**SUPERIOR CHARTER TOWNSHIP PLANNING COMMISSION
SUPERIOR TOWNSHIP HALL
3040 N. PROSPECT, SUPERIOR TOWNSHIP, MI 48198
AGENDA
FEBRUARY 26, 2025 - 7:00 PM**

STPC #25-02 Conditional Use Permit/Preliminary Site Plan - DTE Electric to expand the existing Grenada Electric Substation

DTE Electric Company is seeking approval for a combined Conditional Use Permit and Preliminary Site Plan to expand an existing electrical substation on a 3.76 acres parcel (J -10-18-261-012) located on the east side of Dixboro Road, south of Plymouth Road (see Figure 1). The property is in an Urban Residential District zoned R-4 (Single-Family Residential). The proposed new Grenada Substation would be classified as a "Utility Transmission and Distribution Lines and Pipelines not in Existing Easements or Rights-of-Way" and requires a Conditional Use Permit approval in an R-4 (Urban Residential District).

NOTE: ALL TREES SHOWN IN THIS VIEW ARE SHOWN AT FULL MATURITY

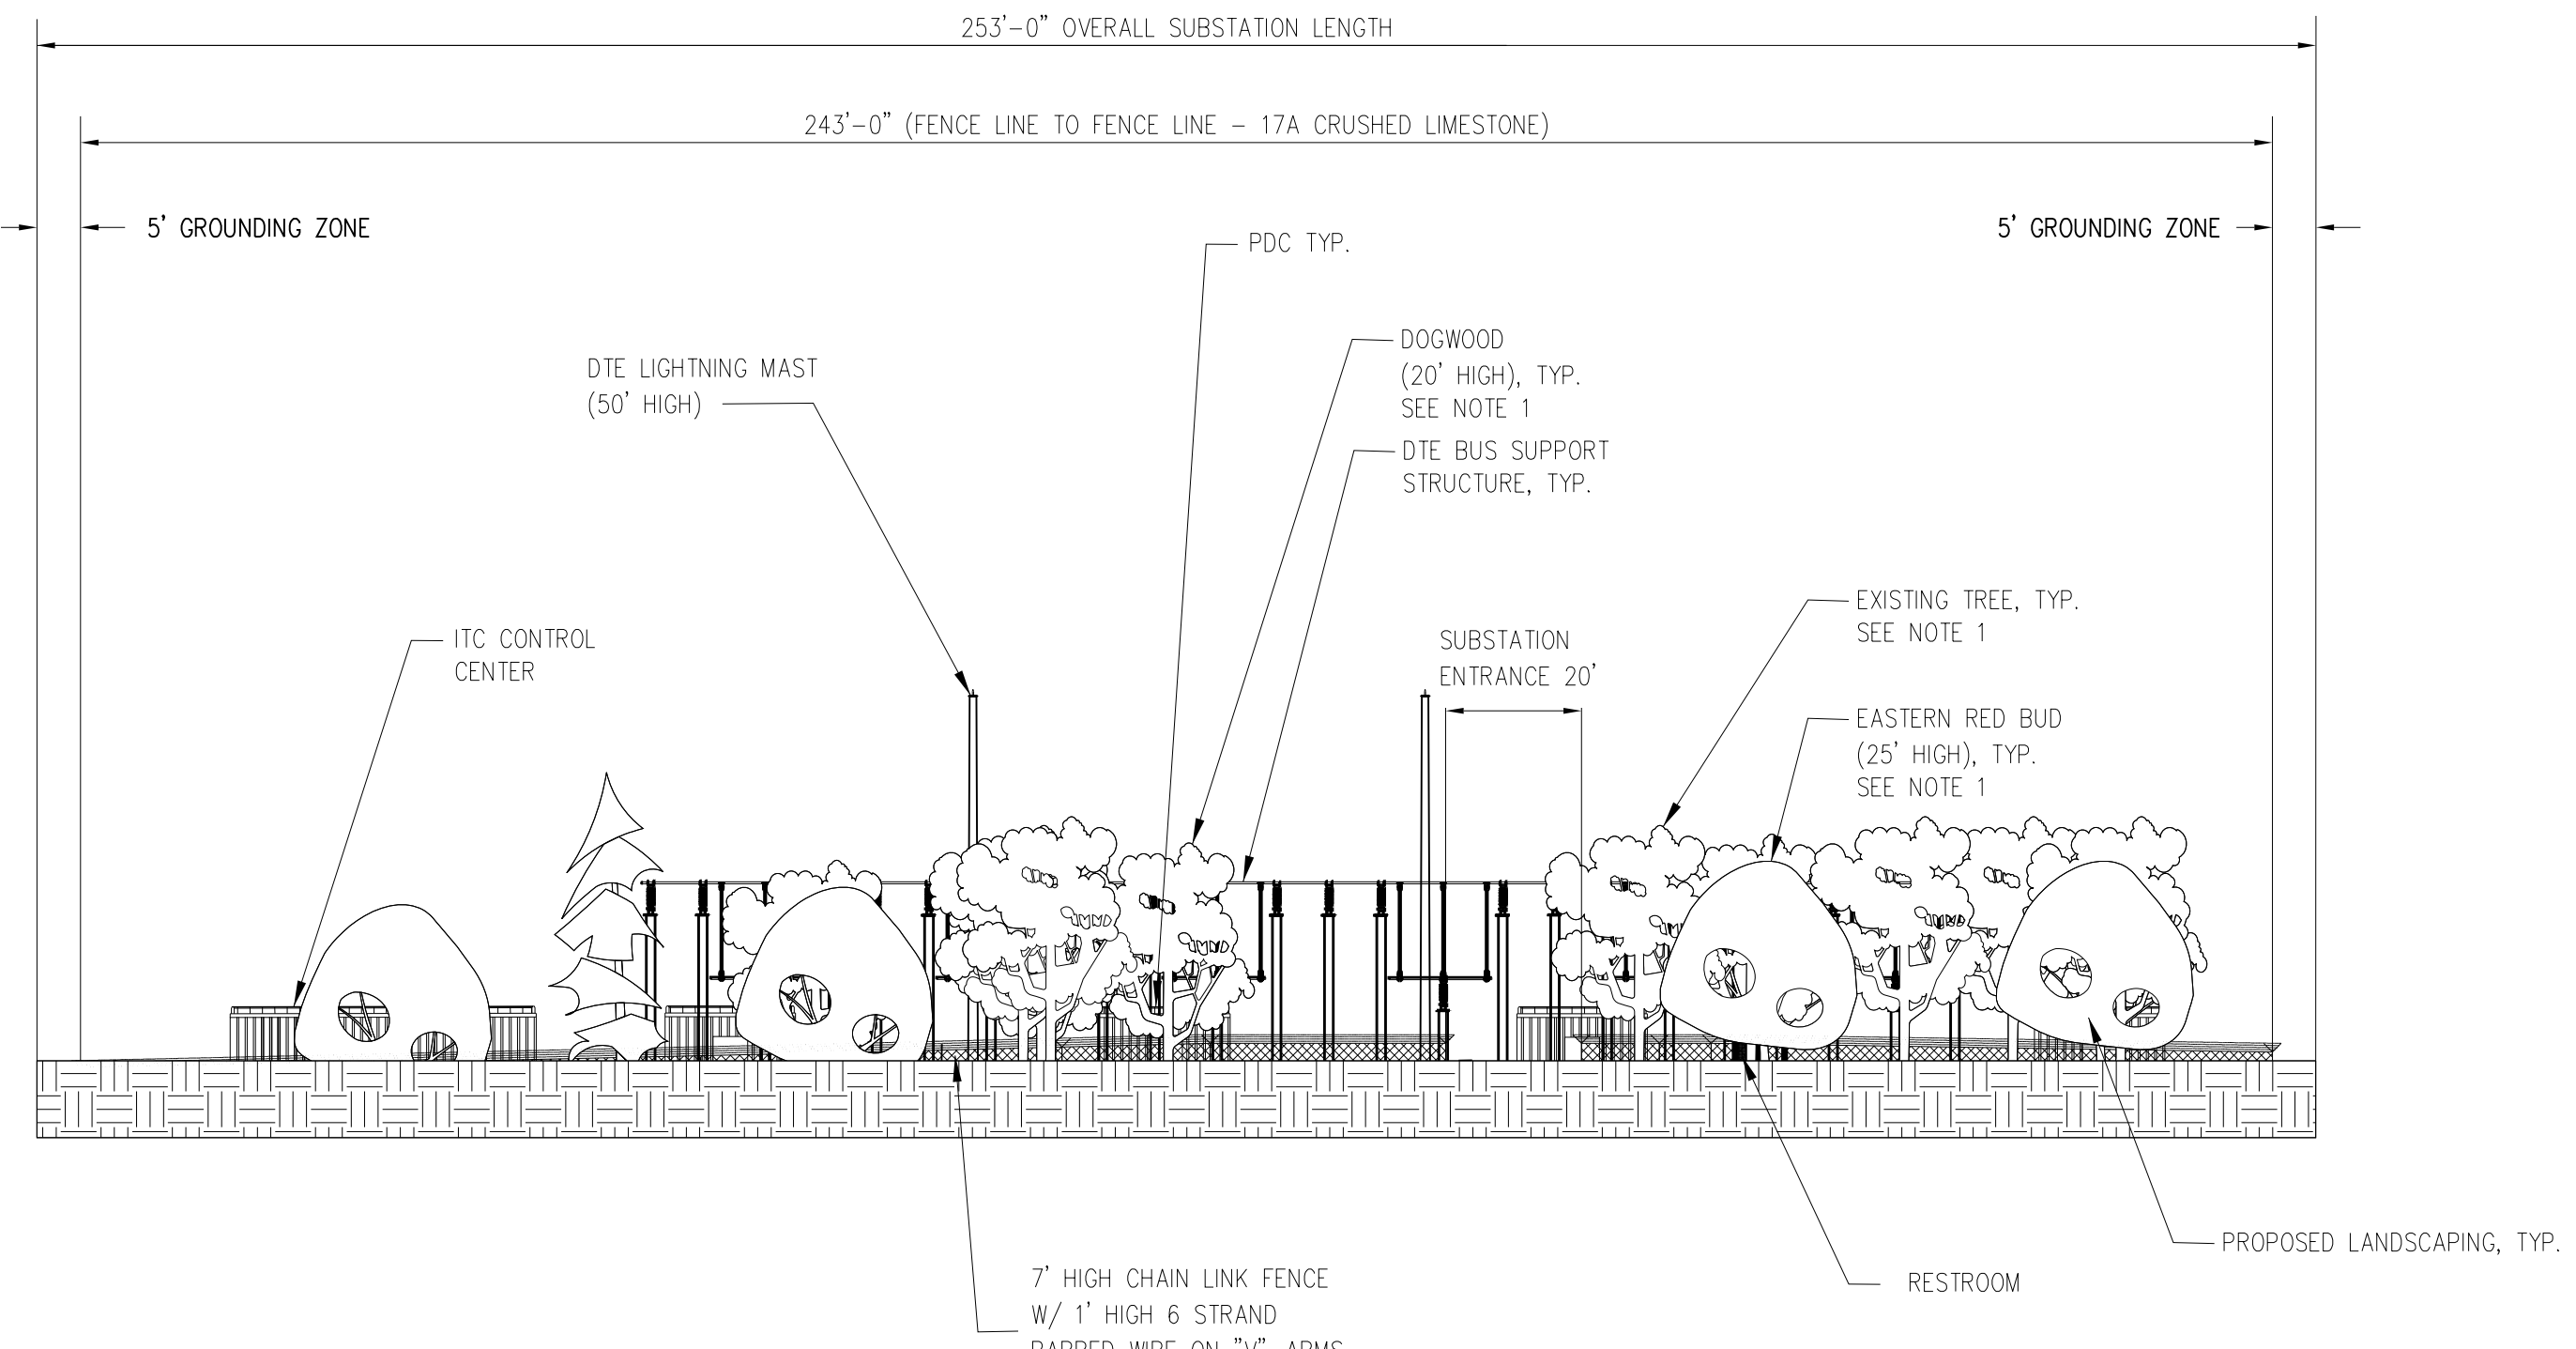
There is an existing substation facility on this property that was constructed around 1990 and the applicant is proposing to improve and expand the facility to improve power reliability in the surrounding areas. The height of the transformer towers proposed was not specified on the plans; however, they appear to be less than the 50 foot high lightning masts shown on sheet 5A1329-10 (Substation Elevations & Section Views).

The Planning Commission may require additional plantings to achieve the screening objectives of Section 14.10D; however, based on a review of substation elevations and section views shown on sheet 5A1329-10, the substation should be adequately screened after landscape reaches full maturity. Furthermore, the substation pad will be at 817 finished grade which is almost 10 feet below the grade of Dixboro Road and there is a natural berm towards the northeast corner of the property.
